Amir Shirts Ltd.

Sufua, Kalikapur Union, Chauddagam, Comilla, Bangladesh
(23.301700, 91.290802)

30th October 2016

Column to be stressed above normal design limits

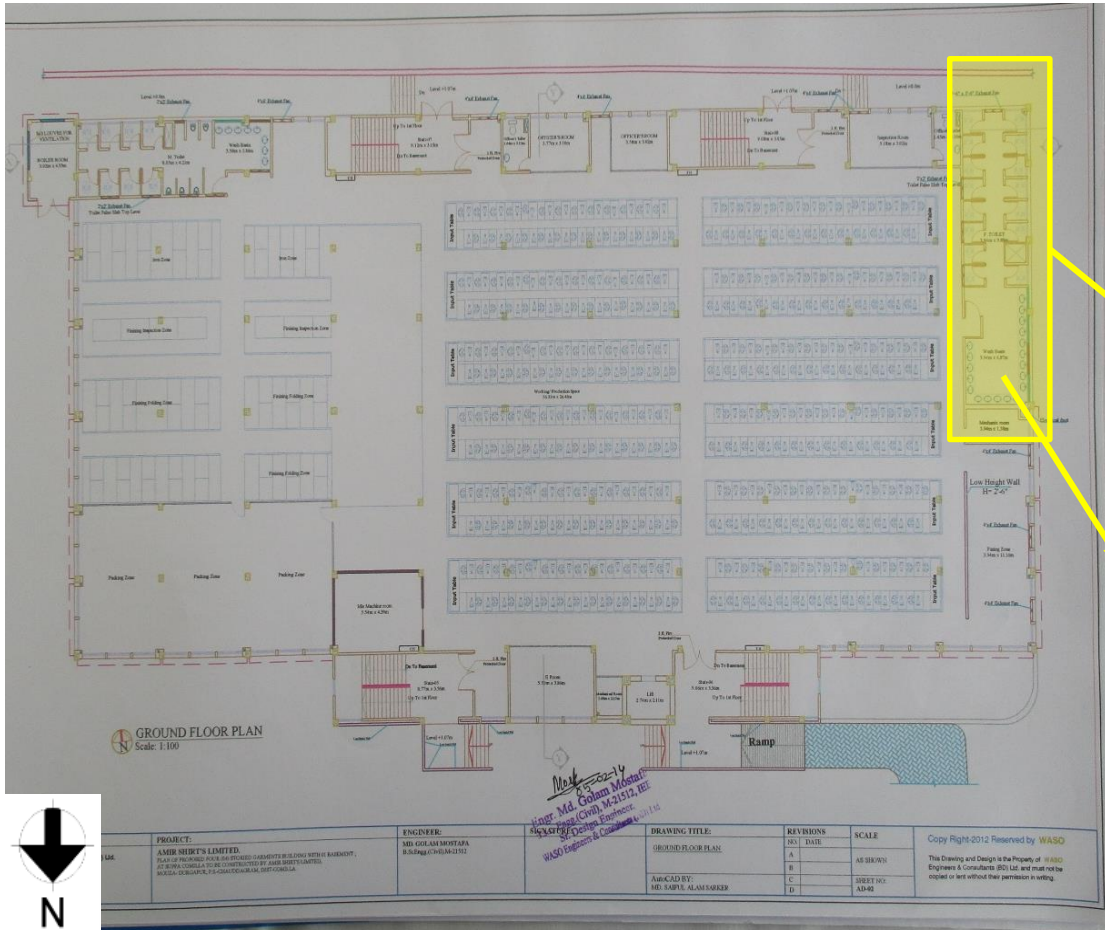
Cursory calculation indicates that Columns appears to be stressed above normal design limits

Item No.	Observation	Recommended Action Plan	Recommended Timeline
1	Column to be stressed above normal design limits(Production Building Unit-1)	Factory Engineer to review design, loads and columns stresses.	6-weeks
2	Column to be stressed above normal design limits(Production Building Unit-1)	Verify in-situ concrete stresses by 100mm dia. cores from min. 4 no. column from ground floor level.	6-weeks
3	Column to be stressed above normal design limits(Production Building Unit-1)	Produce and actively manage a loading plan for all floor plates within the factory giving consideration to floor capacity and column capacity.	6-weeks
4	Column to be stressed above normal design limits(Production Building Unit-1)	Make structural alterations if required as advised by Factory Engineer.	6-months
5	Column to be stressed above normal design limits(Production Building Unit-1)	Continue to implement load plan.	6-months

Cracks on basement walls

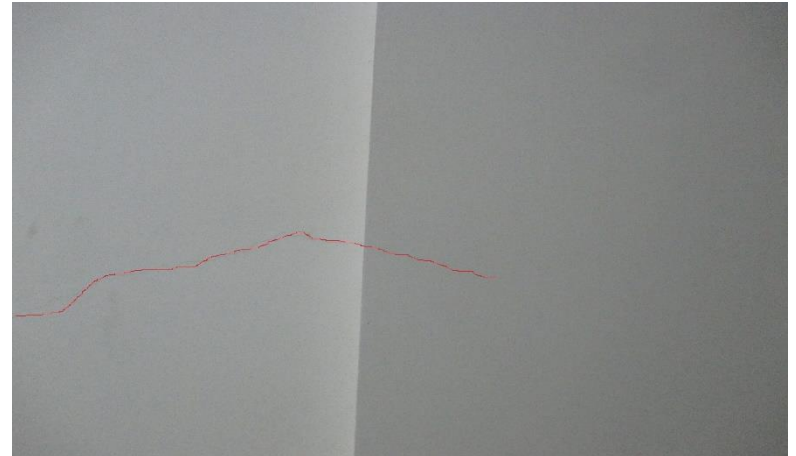
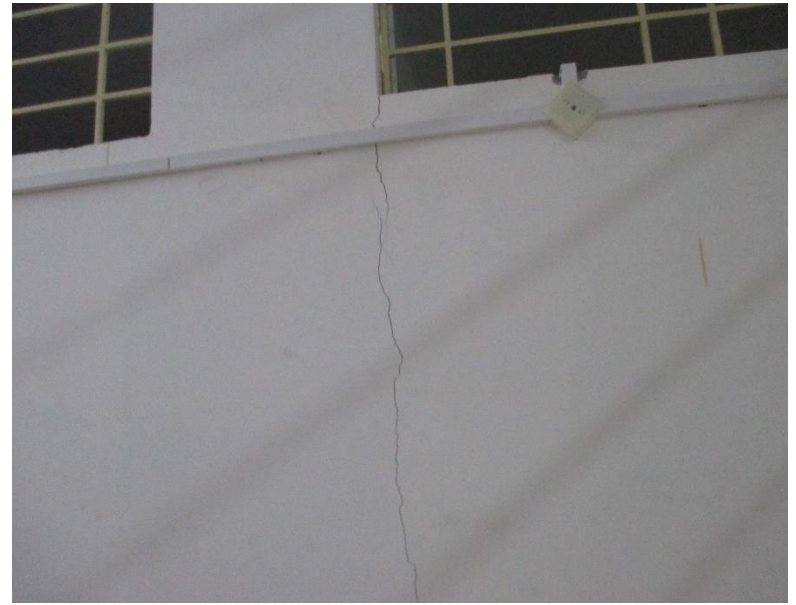
Cracks have been observed at several basement walls. Considering the location of cracks it is recommended that, building engineer requires to investigate and continuous monitor the cracks.

6	Cracks on basement walls(Production Building Unit-1)	Remove finishes to investigate if cracking extends into structure. Any cracks found should be repaired.	6-weeks
7	Cracks on basement walls(Production Building Unit-1)	Continue to monitor building for signs of cracking on on-going basis and take appropriate action.	6-months

Water ponding and Rebar Corrosion at roof.

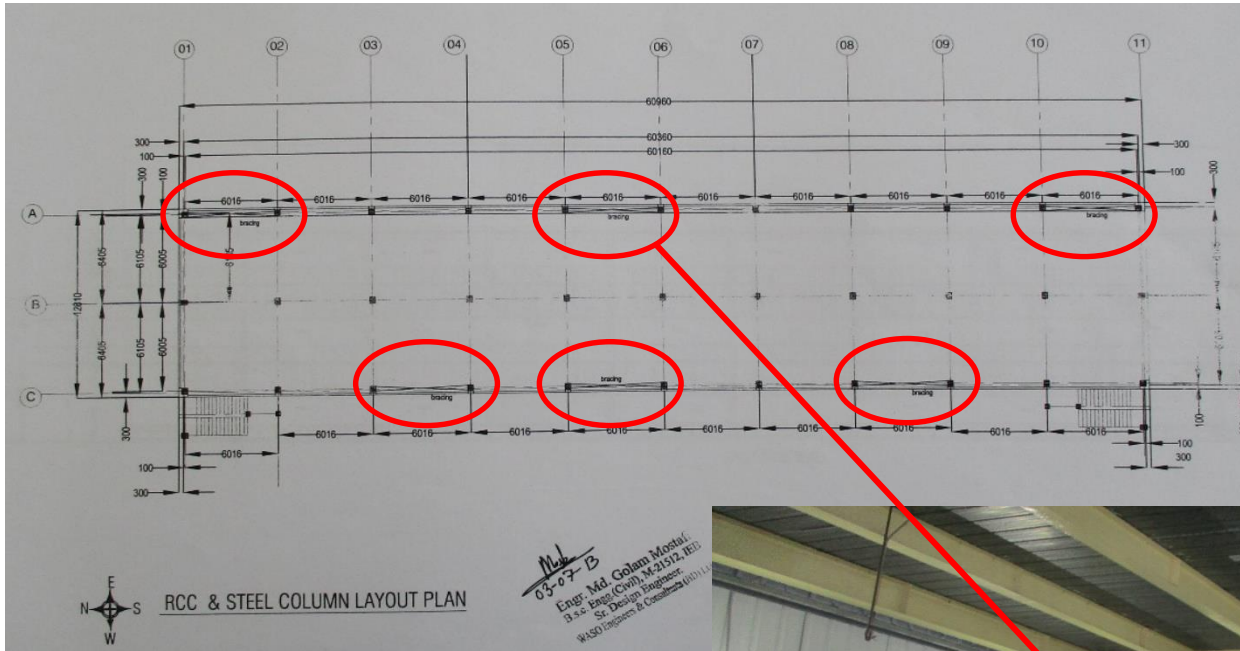
Exposed rebar was observed on roof which is suspected to corrosion. No corrosion resisting coating on rebar has found.

- Water ponding was observed on South-West corner of the roof floor.
- No water proofing layer and proper drainage system has observed on roof.

Missing vertical bracing at south side.

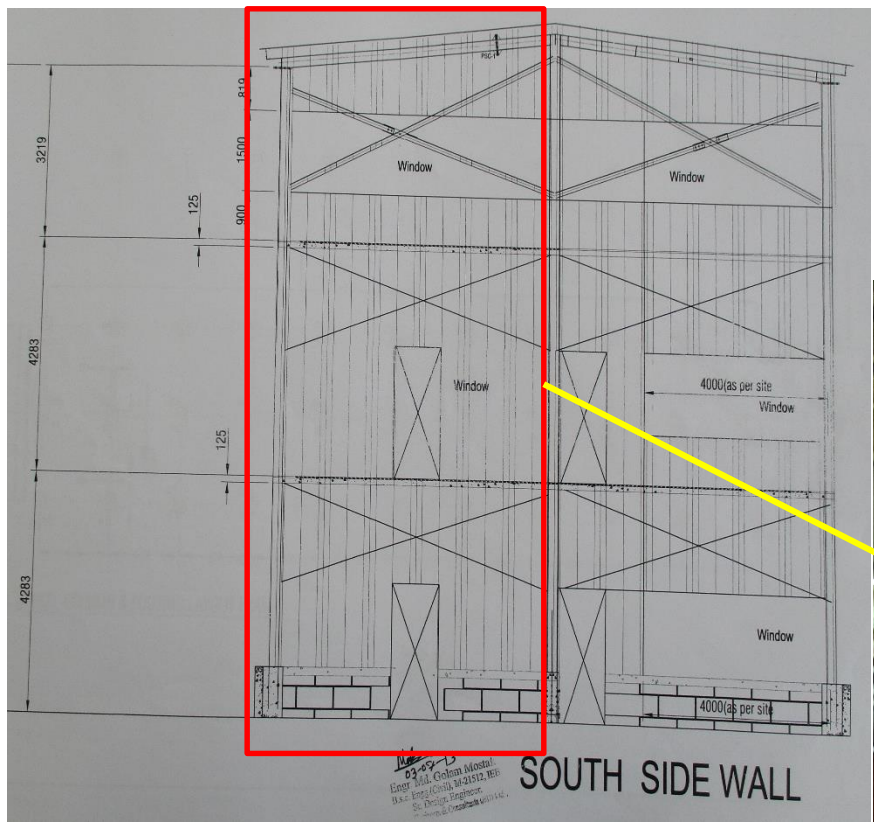
Lack of vertical bracing may effect the overall stability

Bracings has shown on drawing at longitudinal and transverse direction but on site bracings were not installed according to the drawing. Lack of bracing may effect the stability of the building. Building engineer requires to check the stability of the building against lateral loading.

12	Lack of vertical bracing may effect the overall stability(Production Building Unit-2)	Where required, remedial measures to steelwork to be carried out.	6-months

Foundation adequacy requires to be check

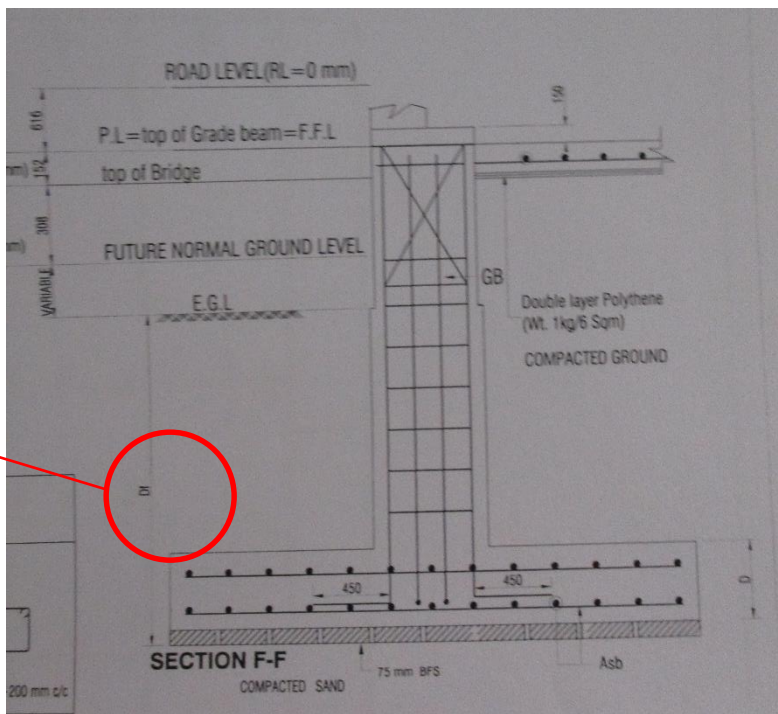
As per soil test report, the foundation was supposed to be at a depth of 2400 mm. But foundation depth of 1500 mm is stated in the as-built drawing. Hence, building engineer requires to review and verify bearing capacity and foundation adequacy for the actual site condition.

Item No.	Observation	Recommended Action Plan	Recommended Timeline
13	Foundation adequacy requires to be check(Production Building Unit-2)	Building engineer requires to review the foundation design considering the bearing capacity of the soil and actual depth of footing.	6-weeks
14	Foundation adequacy requires to be check(Production Building Unit-2)	Carry out remedial works if required.	6-months
15	Discrepancies between drawings & on-site observations(Production Building Unit-2)	Engage a Building Engineer to survey the structure and update a full set of “as-constructed” drawings. Also review the design considering existing condition.	6-weeks
